Docket Number:	15-AFC-02
Project Title:	Mission Rock Energy Center
TN #:	212606
Document Title:	Sid Abma Comments: Reduce Global Warming and Conserve Water
Description:	N/A
Filer:	System
Organization:	Sid Abma
Submitter Role:	Public
Submission Date:	8/3/2016 1:01:36 PM
Docketed Date:	8/3/2016

Reduce Global Warming and Conserve Water

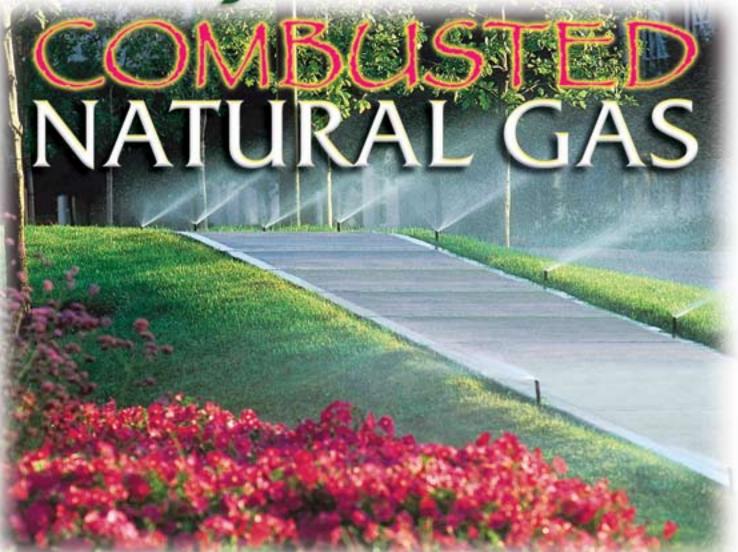
What if Condensing Economizers were to be installed in the exhaust and the heat energy was recovered from the combusted natural gas and supplied to a neighboring company. Cool exhaust would be vented into the atmosphere. The water recovered from the exhaust could be utilized by the power plant or injected into the ground to replenish ground water supply.

For every 1 million Btu's recovered from the exhaust that gets utilized, 117 lbs of CO2 will not be put into the atmosphere.

Might this help the cause to allow the power plant?
